January 13, 2025

RE: 94 4th St. CPD;
DCI2024-00024

Please accept the following information in response to your November 13, 2024 correspondence regarding the referenced project.

MASTER
CONCEPT
PLAN

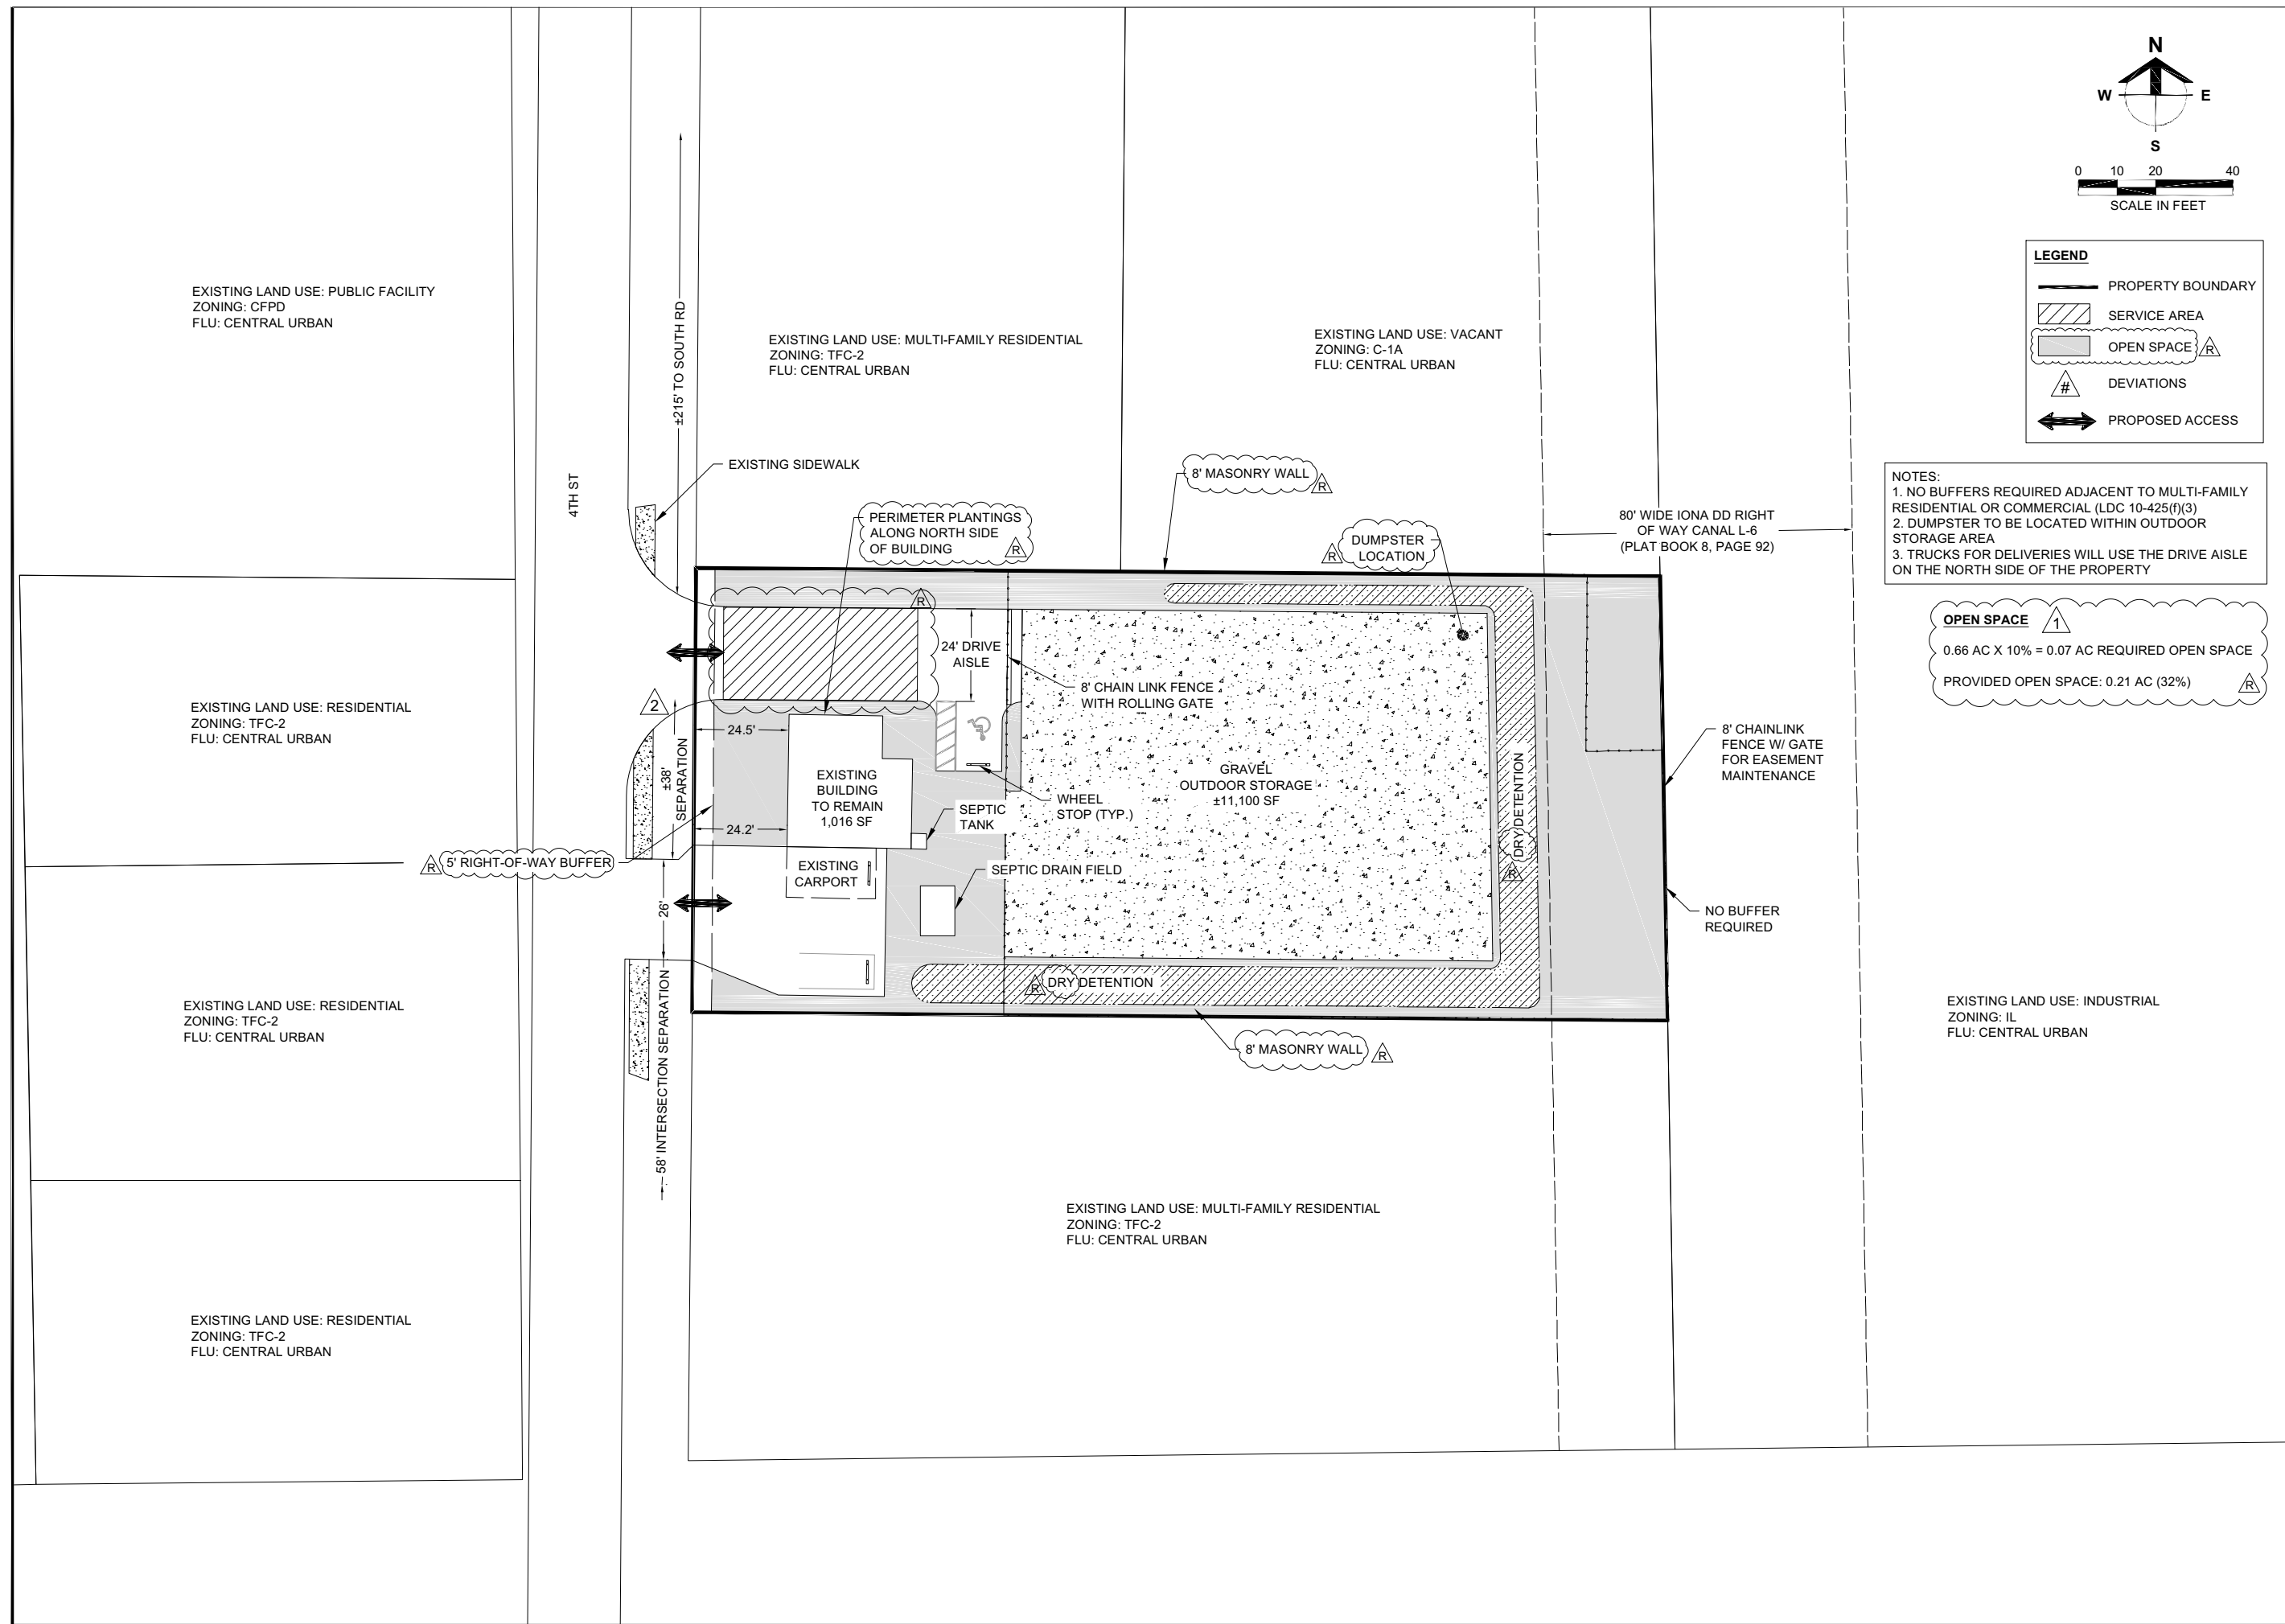
All requested deviations are to be depicted and called out with reference to a key that details the deviation per LDC Section 34-373(a)(6).

Comment 2:

Per LDC Section 33-1742(d), fences and walls must be constructed of conventional and traditional building materials, including, but not limited to, concrete block, brick, wood, decorative aluminum, iron, or steel, chain link or composite products manufactured specifically for fences and walls. Nontraditional materials, including, but not limited to, tires, mufflers, hubcaps, etc., are prohibited. Fabric sheets or nets, or plastic, metal, or vinyl sheets or slats may not be used as part of the fence or attached to a fence for the purpose of effecting privacy or required screening. Master Concept plan shows "8' Fence

w/ Privacy Screen.”

Comment 3:

The location of the proposed fence will need to be revised to show compliance with the required buffers.

Comment 4:

The Master Concept Plan must depict the location and explanation of all existing easements, whether those easements are recorded per LDC Section 34-373(a) (b) 9. If an easement is based upon a recorded document, the official records book reference must be stated. Please revise accordingly.

Comment 5:

The general location of service areas for delivery of goods or services must be shown for all developments that are not residential subdivisions per LDC Section 34-373(a) (6) e. Please revise accordingly.

The revised MCP does not show the code required five foot wide buffer along the rights-of-way. Building perimeter plantings may be used instead of the buffer, but those were not correctly shown on the MCP. Revise to show either buffers required under 10-425(f) or show the location of the building perimeter plantings. Pursuant to LDC Section 10-425(e), commercial development within the Mixed-Use Overlay is only required to provide perimeter plantings on two sides of the building.

The MCP shows an 80 ft. drainage easement on the eastern property line. LDC Section 10-328(a) states that all easements or rights-of-way must be kept clear by the property owners, and LDC Section 10-421 states no landscaping can be proposed in any drainage, utility, or right-of-way easements. Revise the MCP to meet this section.

The MCP does not show a maintenance easement around the proposed detention ponds and the proposed retention areas do not appear to meet code. Please revise to meet LDC Section 10-328(a), 10-329(d) (1), and 34-373(a) (6) or request a deviation. Pursuant to LDC Section 10-328, drainage easement rights-of-way must be kept clear by the property owner. Revise the MCP to meet this requirement.

All deviations are denoted on the Master Concept Plan (MCP) by a symbol, which can be found in the legend. The number in the symbol corresponds to the deviation number from the schedule of deviations.

Acknowledged. The MCP has been amended and it has been noted as an eight-foot block wall. Sight line exhibits have been added to show the view from the property zoned TFC-2 to the northwest and from 4th St.

An eight-foot block wall will be installed in lieu of a fence. The proposed wall will be located on the property line and will meet LDC criteria.

All easements are dimensioned and plat book referenced.

The MCP has been revised to show service areas.

The MCP has been amended to show the existing five-foot wide buffer along the right-of-way. The *Perimeter Planting notation* has been removed from the MCP. Photographs of existing vegetation along the right-of-way on 4th St. have been added for clarification.

Please refer to the dry detention section. No plantings are proposed within the

80-foot easement. An email from Bill Juhl of the Lee County Transportation Dept. is attached, which states the department does not have an issue with the gate placed in the easement. The Applicant is aware that if the fence needs to be removed, it would be at his expense.

Dry detention areas have been labeled on the MCP and do not require a maintenance easement. The dry detention areas have been removed from the easement.
